Re: Strata Energy Ross In Situ Recovery Project
Source Materials License SUA-1601, Docket No. 040-09091
Response to Comments on Submittal for License Condition 12.7

ROSS URANIUM PROJECT SUA-1601 SOURCE MATERIALS LICENSE Response to NRC Comments

Figure A-1

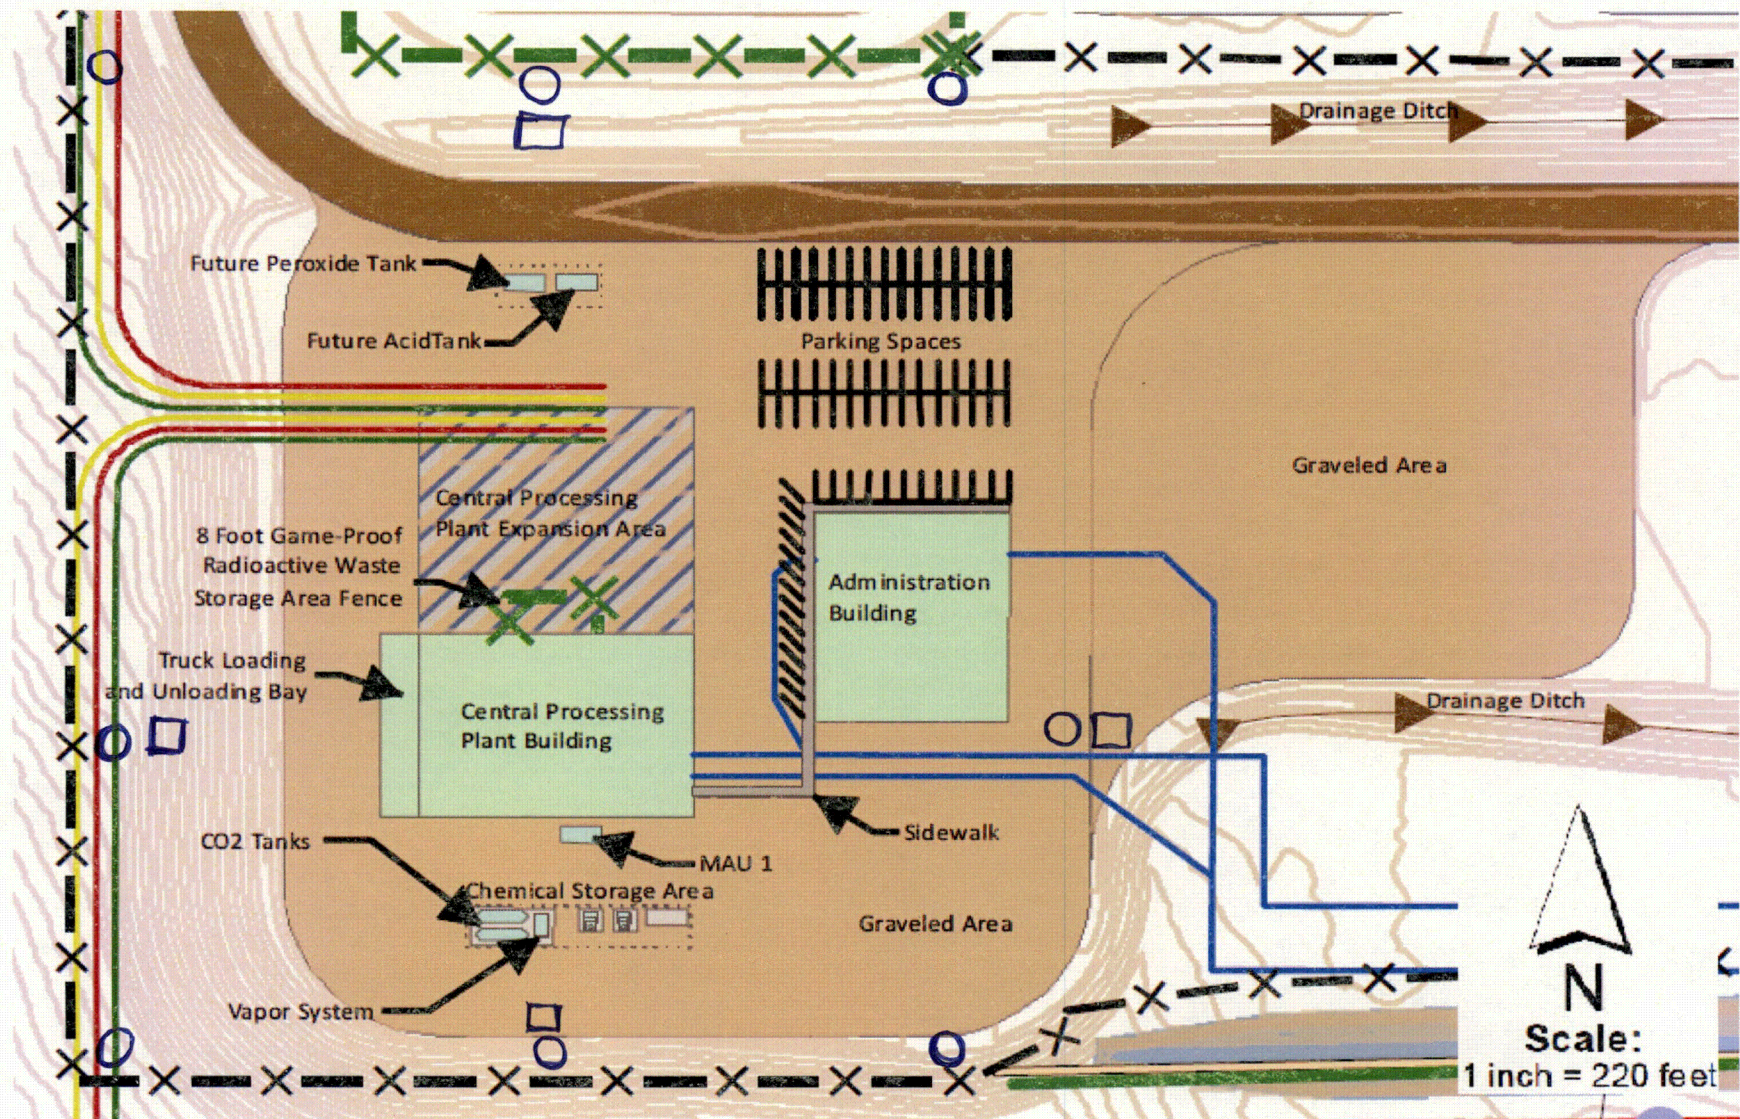
As discussed in the March 1, 2015 letter, Strata will commit to utilizing the approach specified in Section 4.2.2 of NRC's draft Interim Staff Guidance (ISG) FSME-ISG-01 titled "Evaluations of Uranium Recovery Facility Surveys of Radon and Radon Progeny in Air and Demonstrations of Compliance with 10 CFR 20.1301". As discussed in the ISG Section 4.2.2, "If such models are used for transport calculations, NRC staff should ensure that the licensee has measured (or the applicant commits to measuring) radon or radon progeny in air to verify that the predicted concentrations are not exceeded". In order to provide NRC staff with reasonable assurance that the predicted concentrations are not exceeded, Strata will conduct surveys to measure the radon in air.

Strata will take monthly air particulate grab samples in the four cardinal directions around the CPP. Samples were chosen to be taken at the four cardinal directions to provide representative data of the concentration levels of particulates in the area around the CPP. The samples will be averaged monthly to determine an average concentration level. The grab sample locations are shown on the map in Attachment 2. The particulate samples will be taken according to procedures outlined in the TR Section 5.7.3.1. Strata has also committed to placing eight (8) passive alpha-track detectors around the perimeter of the CPP to validate the concentration levels of a predictive model for radon and radon progeny. The average monthly concentration levels obtained from the alpha track detectors and the average monthly concentration levels obtained from the particulate samples will be analyzed against the associated levels obtained through surveys within the plant. Although it is anticipated that concentration levels in the plant will be much higher, the average concentration levels from the surveys conducted in the area outside the CPP will be compared to the average concentration levels found in the plant. The most conservative concentration level will be used in determining dose to workers while in the CPP area. This will include workers performing work outside of the CPP building, but within the general area of the building. The "CPP General Area" will be the area designated as the "Controlled Area" in the map attached as Attachment 3.

Figure A-2

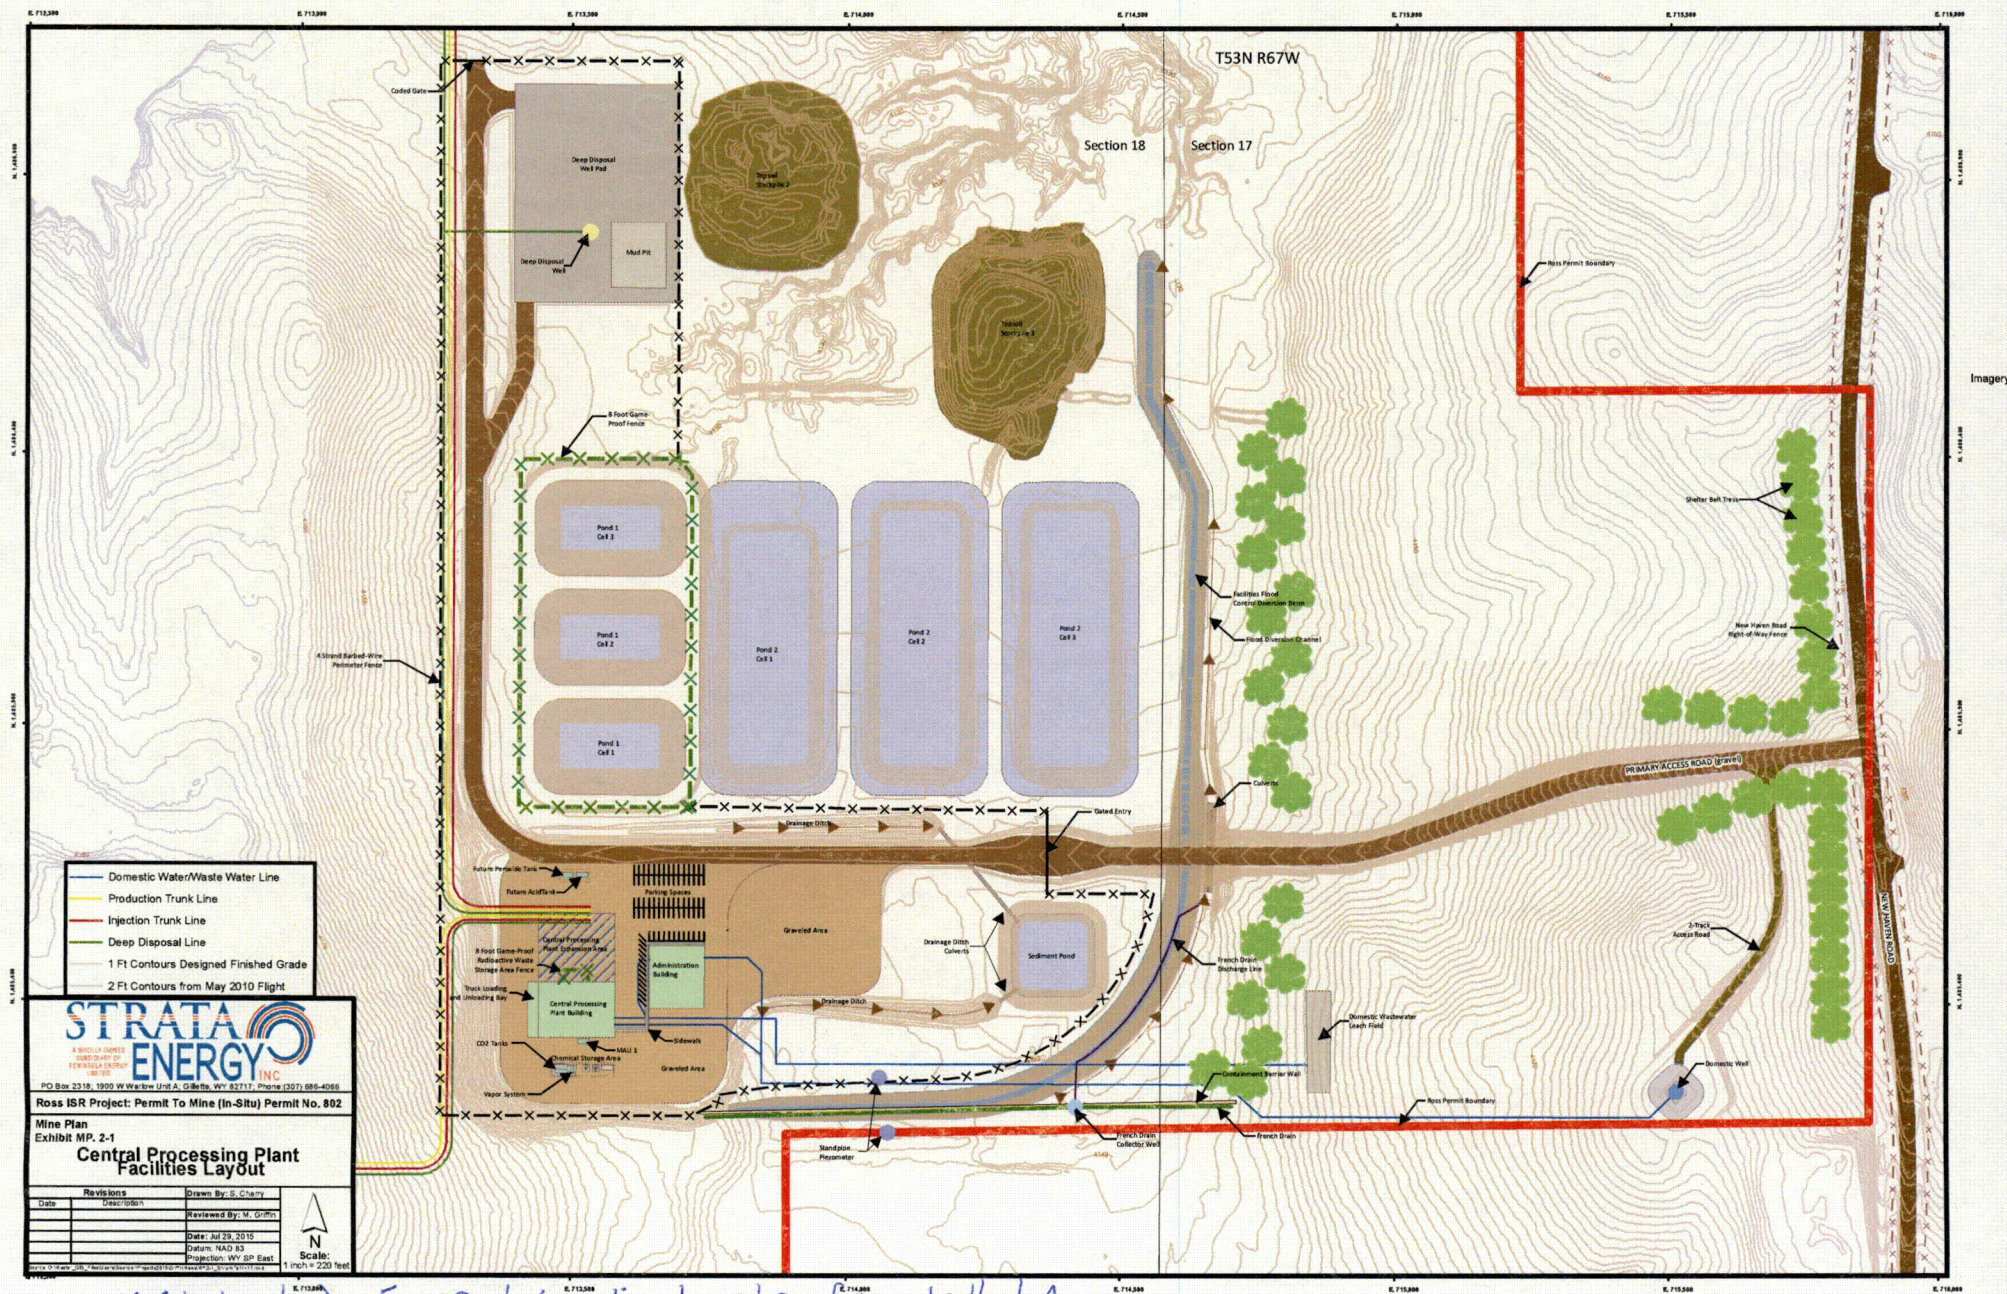
The information provided by Strata in response to LC 12.7(C) does not address any additional workplace air sampling inside structures outside the CPP (e.g., header houses) to assess internal exposure, or additional external exposure monitoring. Also, the NRC staff has not approved the use of the MILDOS-AREA code for estimating annual occupational dose in License Areas outside the CPP. The staff has previously approved a program for accounting for occupational dose outside the CPP (NRC 2014d).

Comment: Strata should explain how it will account for annual occupational dose received in areas outside the Central Processing Plant (CPP) (i.e., throughout the entire License Area) for employees who are already monitored in accordance with 10 CFR 20.1502 using workplace air sampling and personnel dosimetry.
